Xian, China – 27 – 31 July 2009

Question: 4/15

SOURCE¹: CopperGate CommunicationsTITLE: G.hn: Using Two Symbols for the Header of a PHY frame on Coax

Figure 7-10/G.9960 – Functional diagram of the Header Encoder

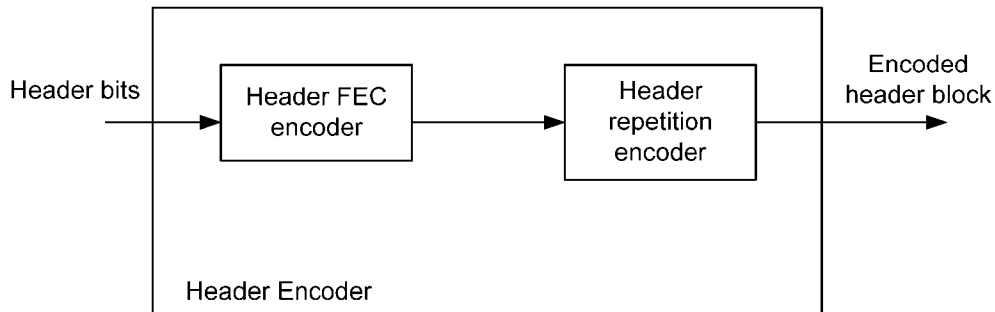
The functional model of the header encoder is presented in Figure 7-10. It contains an FEC encoder and a Header Repetition Encoder (HRE).

The bits of the PHY-frame header shall input the Header FEC encoder in their original order and encoded as described in §7.1.3.2. The size of the FEC codeword and the coding rate of the Header FEC encoder are described in Table 7-19.

The FEC codeword enters the HRE. The HRE shall operate as follows:

- The FEC codeword shall be first copied M times, where $M = \text{ceiling}(D \times k_H / N_{FEC})$, k_H is the number of bits to be loaded onto the OFDM symbol carrying the header, and D is the number of symbols to be used for header transmission
- The encoded header block shall be formed by concatenation of M copies of the header FEC encoder output. As each codeword is cascaded to one another, the bits (b_i) within a codeword shall be cyclically shifted by 2 bits as follows:
 - The 1st FEC codeword copy shall be formed as $\{b_0, b_1, \dots, b_{NFEC-2}, b_{NFEC-1}\}$.
 - The 2nd FEC codeword copy shall be formed as $\{b_2, b_3, \dots, b_{NFEC-1}, b_0, b_1\}$.
 - The 3rd FEC codeword copy shall be formed as $\{b_4, b_5, \dots, b_{NFEC-1}, b_0, b_1, b_2, b_3\}$.
 - ...

- The M^{th} FEC codeword copy, where $M > 3$, shall be formed as $\{b_{(2 \times M - 2)}, b_{(2 \times M - 1)}, \dots, b_{N_{\text{FEC}} - 1}, b_0, b_1, \dots, b_{(2 \times M - 4)}, b_{(2 \times M - 3)}\}$.

Valid values of D are either 1 or 2. Details ~~for powerline and phoneline~~ are for further study.

~~For coax (baseband and RF) the number of PHY-frame header shall be two, i.e., $D = 2$.~~
